## Product / Process Change Notification (PCN)

**PCN Number:** PCN\_SwTATU\_SwTATV\_20250305

**Affected Series:** WS-TATU, WS-TATV

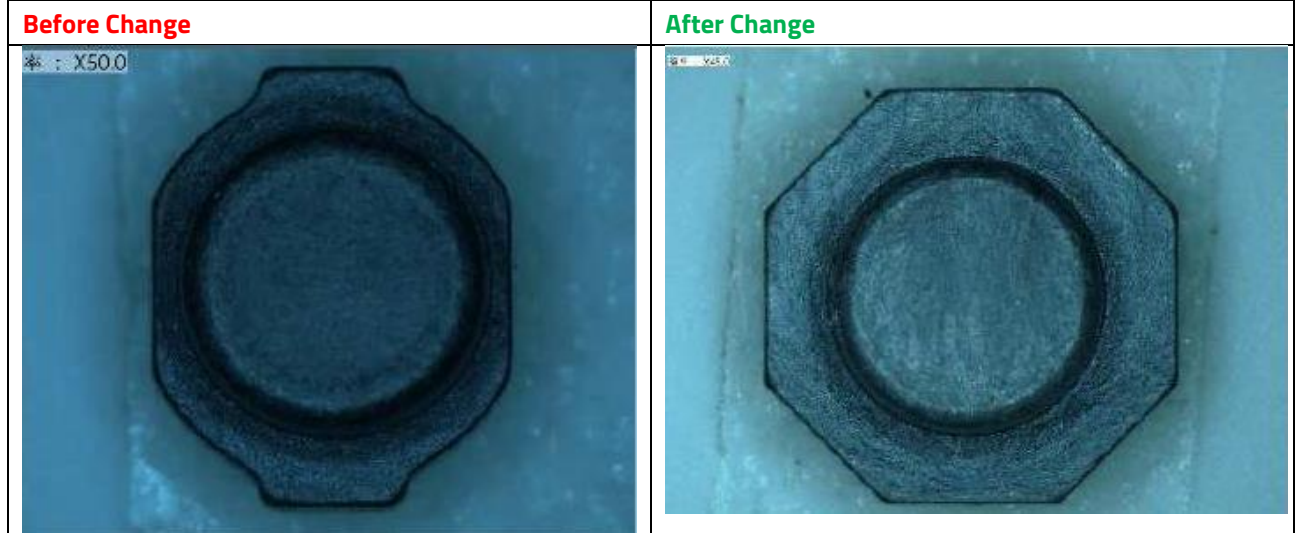
In order to enhance the product reliability, Würth Elektronik eiSos makes the design change of the inner structure & adding polyimide tape.

**Before Change**

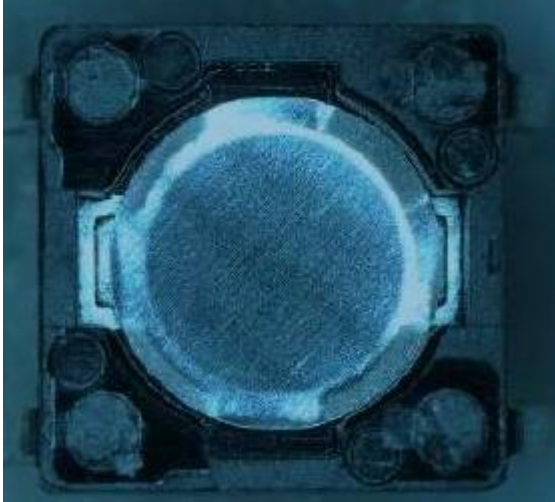
2. Inner base shape change:

3. Add the Polyimide tape:
